North Eastern Regional Power Committee

**Sub: 85वीं संरक्षण समन्वय उप-समिति (पीसीसी) बैठक का कार्यवृत्त/ Minutes of 85<sup>th</sup> Protection Coordination Sub-Committee (PCC) Meeting**

### **85<sup>th</sup> Protection Coordination Sub-Committee Meeting**

**Date:** 06/11/2025 (Thursday)

### **B.9 Grid Disturbance in Tipaimukh area of Manipur on 10th Oct'25:**

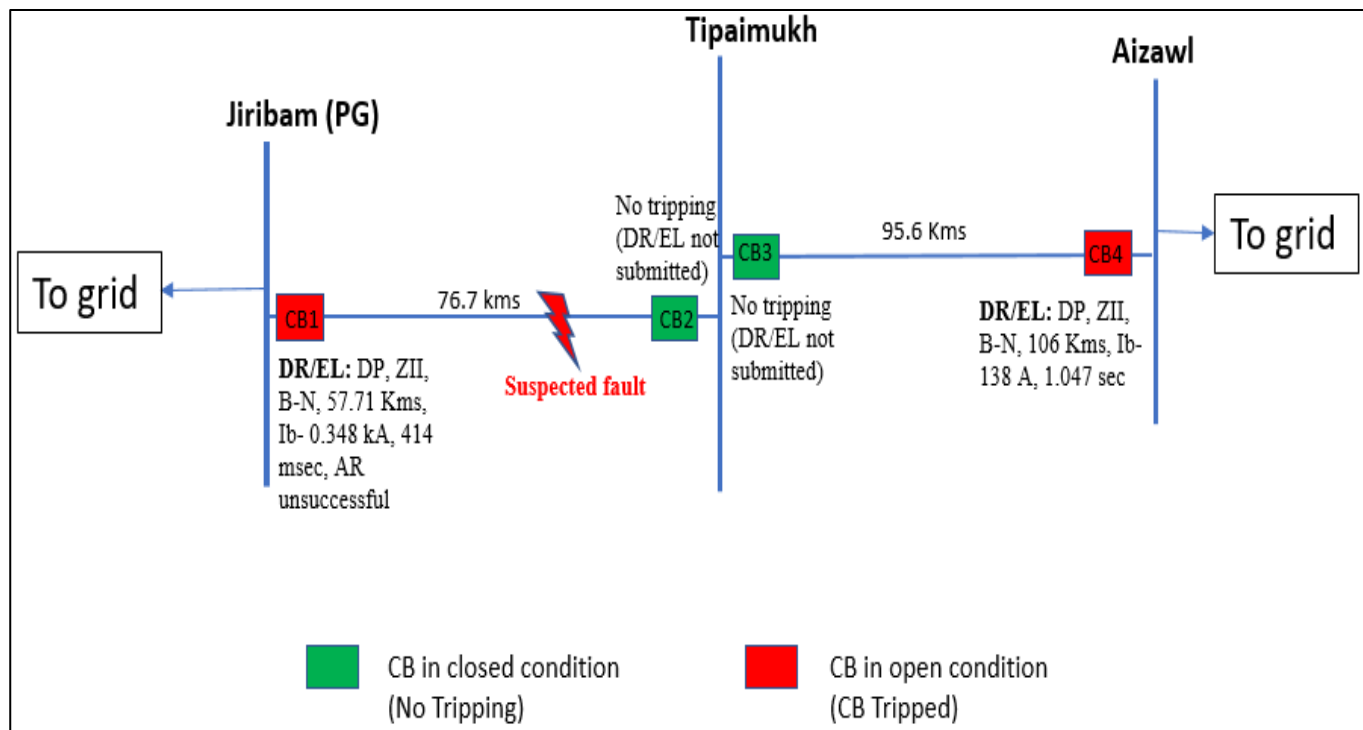
For 132 kV Aizawl - Tipaimukh Line: High resistive fault of slowly growing fault current cleared by the Main protection in DP, ZII, B-E. Total fault duration is of 1047 msecs.

For 132 kV Jiribam - Tipaimukh Line: High resistive fault of slowly growing fault current cleared by the Main protection in DP, ZII, B-E in 83 msecs. Total fault duration is of 414 msecs. AR operated after 2.5 seconds and tripped again in 310 msecs.

The root cause could not be concluded from the above analysis without the DR & EL of Tipaimukh end.

MSPCL is requested to share the same & inform the CB status observed during the event at Tipaimukh.

However, it seems the fault was in the 132 kV Jiribam- Tipaimukh line.

NERTS is requested to confirm the actual fault location. Also, requested to share the reason for AR operation for ZII fault without carrier received.

NERTS apprised that the fault occurred in the Jiribam-Tipaimukh line due to vegetation infringement from outside the line corridor.

NERLDC informed that the operation of CB2 (Tipaimukh end) was not clear as no DR and EL were submitted by MSPCL.

MSPCL informed that the CB2 had operated correctly on 17<sup>th</sup> and 21<sup>st</sup> October'25. However, there may be some issue with the settings.

Forum requested MSPCL to send the settings of Jiribam-Tipamukh line from Tipaimukh end to NERPC and NERLDC for analysis.

**B.10 Grid Disturbance in Sanis & Wokha area of Nagaland on 8th Oct'25:**

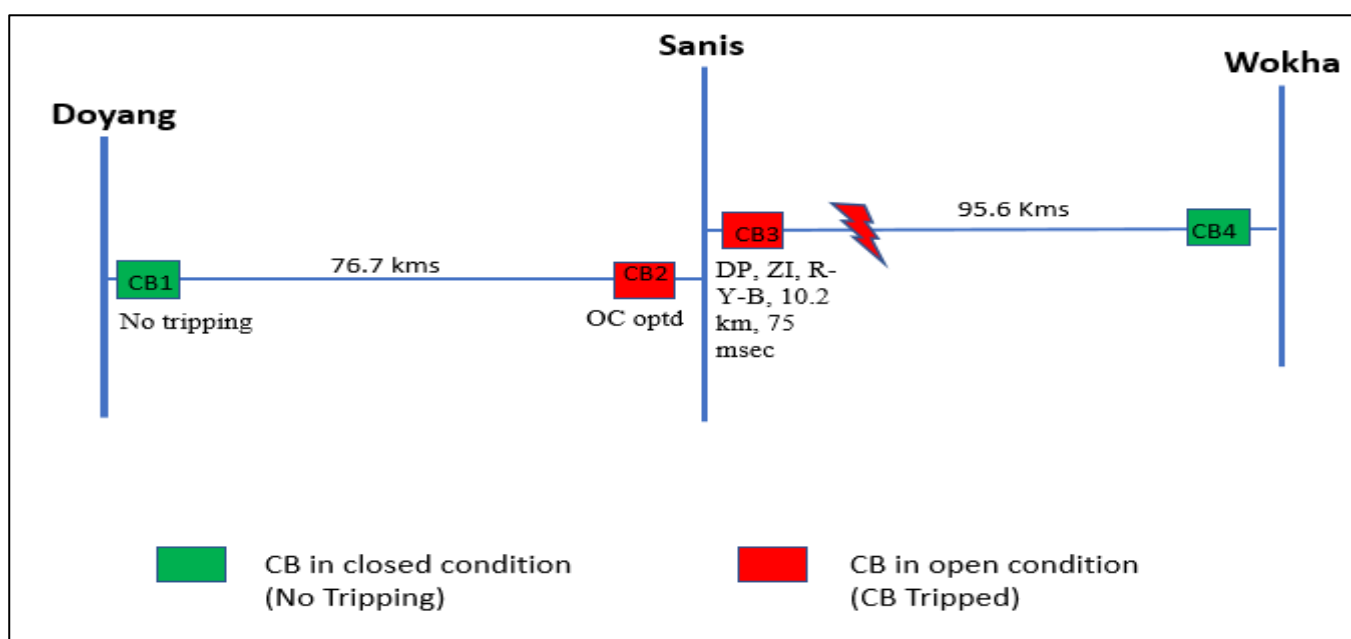
As per DR analysis for Sanis end of 132 kV Wokha – Sanis line, metallic fault in RYB (Ir-4.2 kA, Iy-3.8 kA, Ib:3.8 kA) initiated at 14:19:11.826 Hrs which was cleared 75 msecs from Sanis on operation of DP, ZI.

132 kV Doyang-Sanis line tripped from Sanis end. As per the submitted EL (main relay) for Sanis end, no tripping command issued by the main protection. DR&EL for backup relay not shared by DoP, Nagaland.

Protection issues observed:

- Tripping of 132 kV Doyang-Sanis line from Sanis end for fault beyond the line (reverse direction) seems unwanted.

- DR downloading facility need to be implemented at Siemens make backup relay at Sanis.

During, 83<sup>rd</sup> & 84<sup>th</sup> PCC Meeting forum suggested to check the CT polarity for Sanis Substation. However, no action has been taken by DoP Nagaland which a matter of serious concern.

DoP Nagaland updated that they will check the CT polarity at Sanis substation within a fortnight. MS NERPC strongly urged DoP Nagaland to rectify the issue as it is causing multiple GDs and they been consistently delaying the rectification work.

### **B.11 Multiple GD event at Kohima & associated areas during Oct'25:**

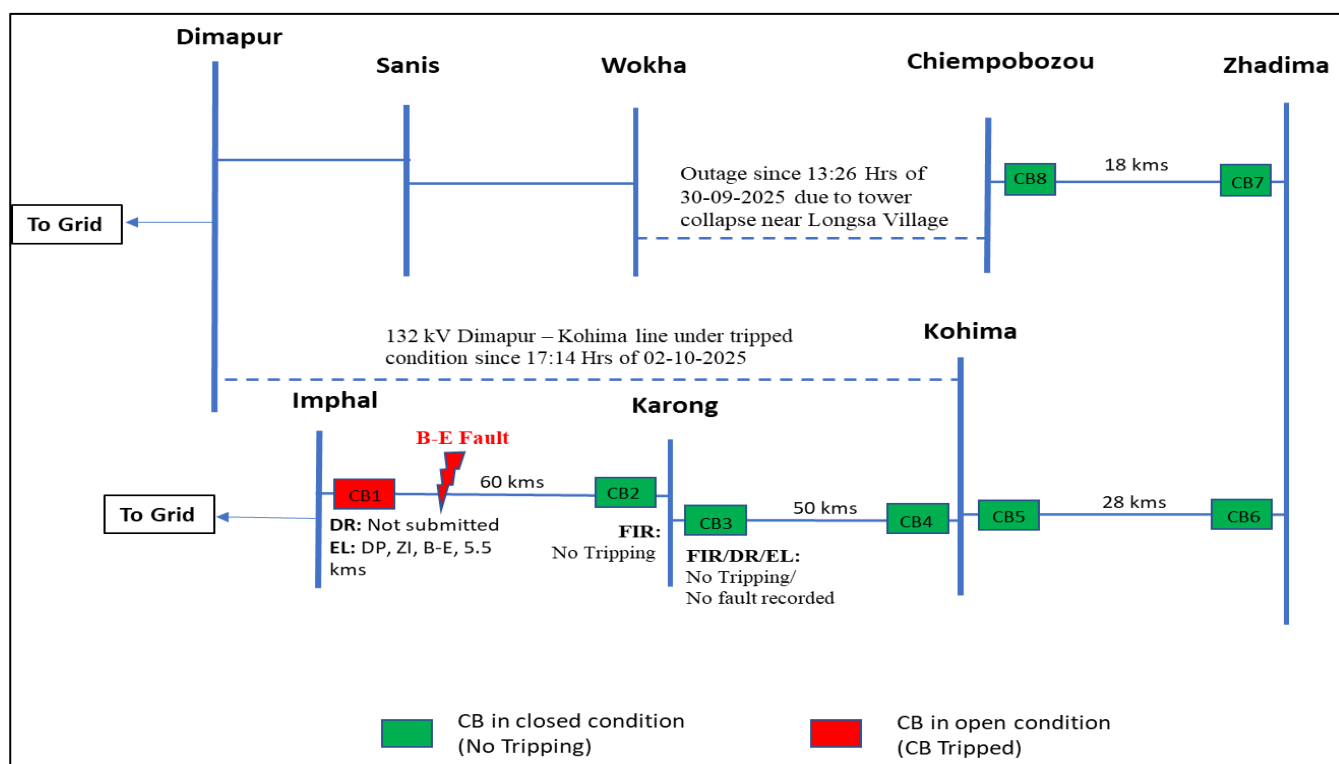
**DoP, Nagaland is requested to ensure the following for the reliability of the capital area:**

1. Ensure healthiness of the 132 kV Dimapur - Kohima line by clearing tree/vegetation urgently.
2. Expedite the restoration of 132kV Wokha - Chiphebozou line (under outage from 13:26 Hrs on 30.09.2025 after the Tower collapsed at Longsa Village).

Regarding the Wokha-Chiepobozou line, DoP Nagaland informed that a tower has collapsed near Longsa village. Forum strongly requested to revive the line using ERS at the earliest to ensure reliability of the network. For ERS, Forum requested DoP Nagaland to take up the matter with Powergrid.

Forum also exhorted DoP Nagaland to ensure healthiness of the 132kV Dimapur-Kohima line by clearing tree/vegetation urgently.

#### **B.17 Outage of 8 CB's at 400 kV Bus I at Balipara (PG) on 04-Nov-2025 at 17:07 Hrs:**

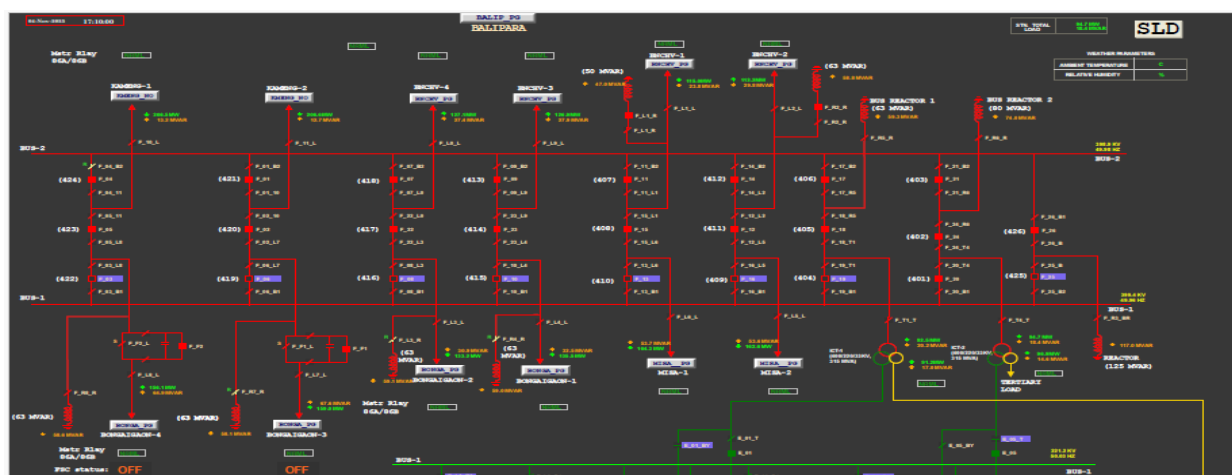
During the incident, out of the nine circuit breakers (CBs) connected to the 400 kV Bus I, eight CBs tripped simultaneously, while only one CB (Bay 401) remained in service. Owing to the availability of Bay 401, a complete outage of Bus I was avoided.

As per PMU data and real-time information received from NERTS, no system fault was detected during the event. Subsequently, all affected bays were re-energized. Hence, NERTS (PGCIL) is requested to investigate and share the root cause of this multiple-bay tripping incident and to propose suitable remedial measures to prevent recurrence of such critical events.

**C.2 Grid Disturbance in Rokhia and Mohanpur S/S of Tripura Power system on 18th Sept'25:**

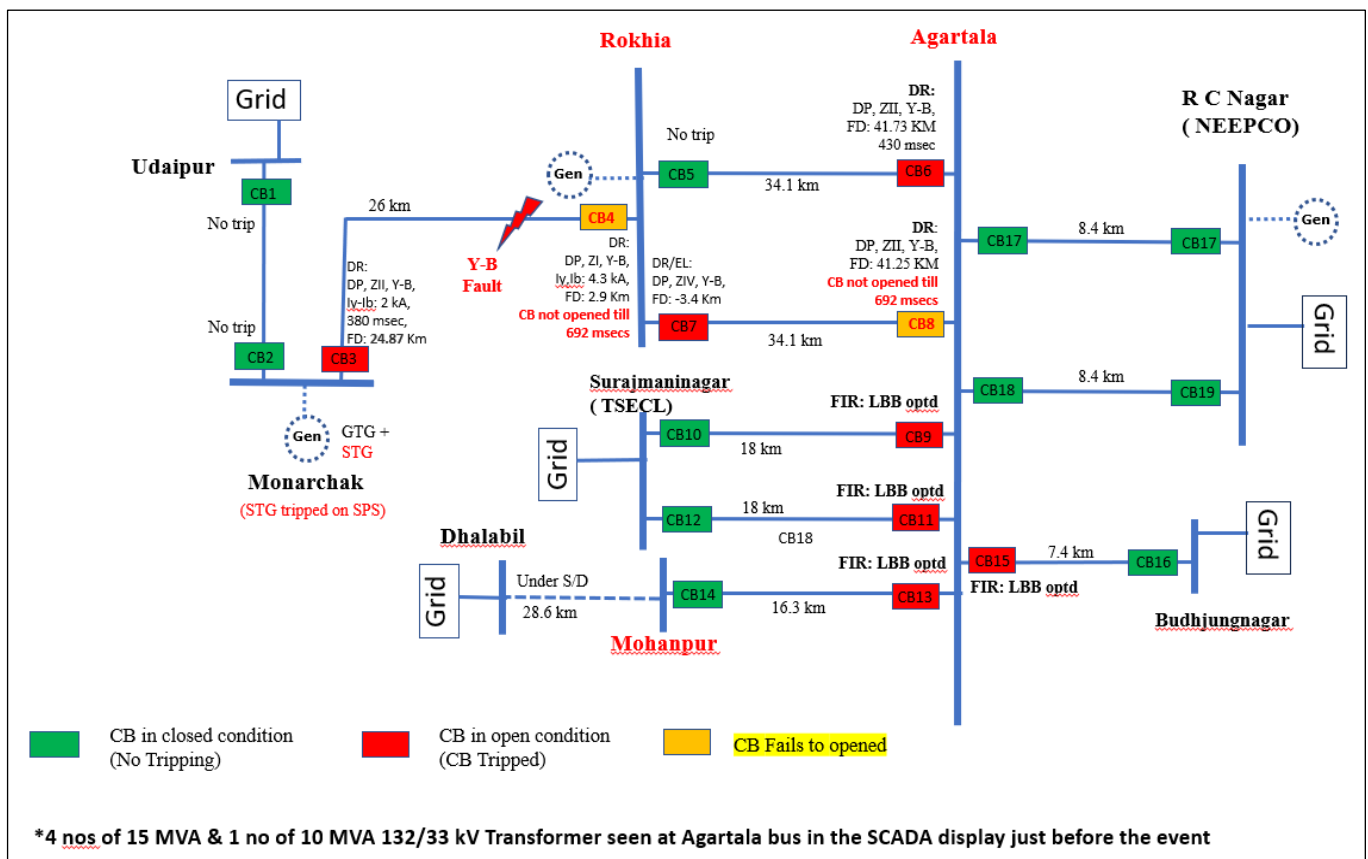
At 10:35 Hrs of 18-09-2025, all the connected circuits to Rokhia and Mohanpur S/S got tripped simultaneously resulted into the blackout of the Rokhia and Mohanpur S/S of Tripura. Load loss of 17 MW and Generation loss of 39 MW occurred.

2. Forum also requested PowerGrid to take an online training program on CB maintenance.
3. Regarding non-operation of CB8, TPTL informed that master trip relay contact had got burnt and will change the relay shortly.

4. Forum also noted that LBB operation has not taken place correctly at Agartala and instructed TPTL to provide LBB healthiness report to NERPC and NERLDC.

Tripura informed that DCRM tests were conducted for CB3 and CB8 and the test results show that there are some issues with the CBs. He further informed that DCRM tests will be conducted again and if the results are similar, the CBs will be replaced. Forum requested PGCIL to conduct a physical training program of testing of CBs.

#### **C.4 (Ref: Agenda B.10, 84th PCC) Grid Disturbance in Kolasib, Tuirial & Bairabi HEP of Mizoram Power System on 15th Sept'25:**

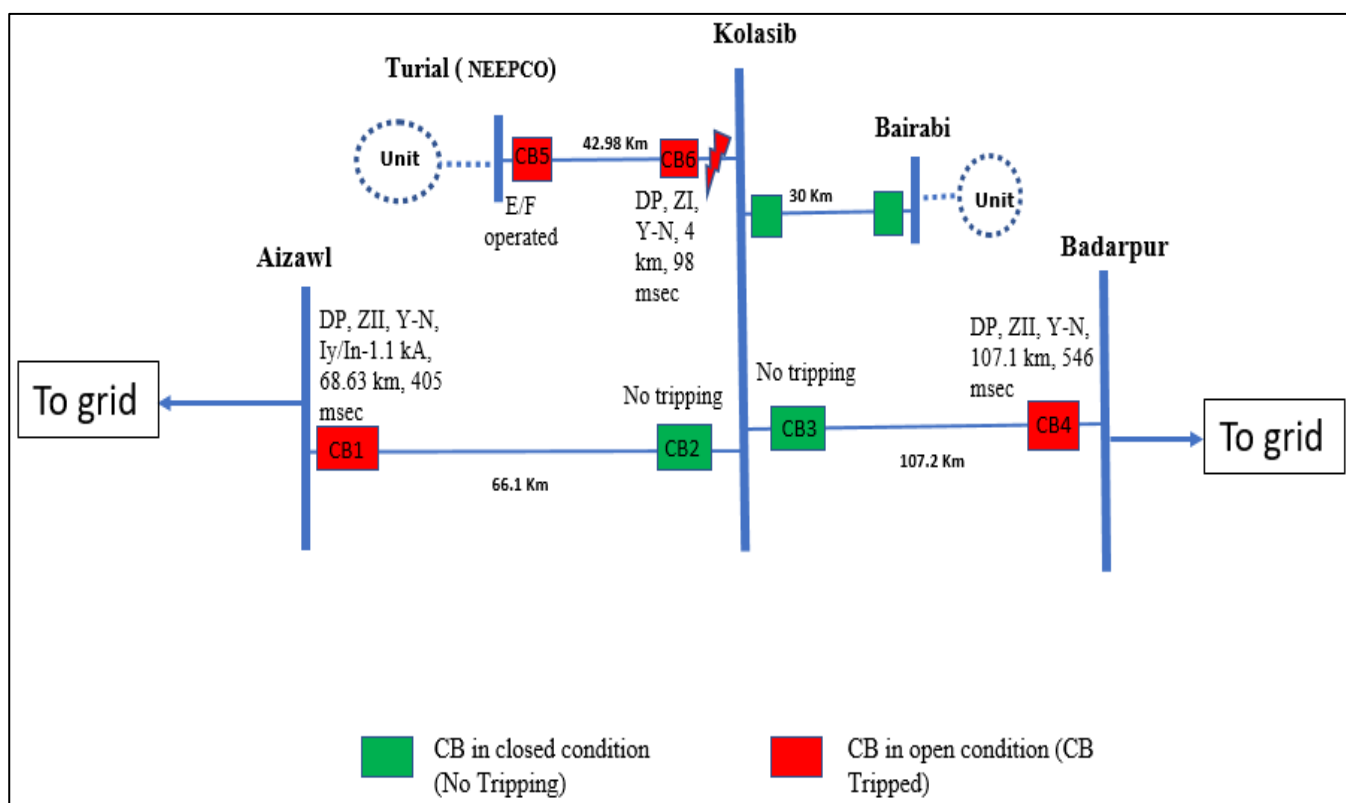
As per DR analysis, Y-N fault (Iy-1.1 kA, In-1.1 kA) initiated at 15:51:25.738 Hrs which was cleared within 405 msec from Aizawl end on operation of DP, ZII and within 546 msec from Badarpur end on operation of DP, ZII. There was no tripping from Kolasib end.

1. Mizoram informed that fault occurred in the Tuirial-Kolasib line and line CVT is available on the Tuirial-Kolasib line. However, NERLDC raised the availability as Kolasib end using Bus PT for protection 132 kV Kolasib – Tuirial line as observed during the DR as well as SLD shared after the incident. Hence, Mizoram to cross check once again.  
Hence, fault in the broken Y-ph conductor connecting CB to Islotaor seen by the Bus PT in ZI which seems correct.
2. Likely High set E/F enabled at Tuirial end of 132 kV Kolasib line which need to be disabled at Tuirial. E/F setting needs to be reviewed at Tuirial & Kolasib end along with its directionality.
3. Additionally, the forum requested Mizoram to take all measures to maintain the healthiness of the Tuirial-Kolasib line.
4. NERPC audit planned for Kolasib SS during Last week of Oct'25.

**Hence, P&ED, Mizoram to share the action plan against deliberation point no 1 & 4 and NEEPCO for point no.2.**
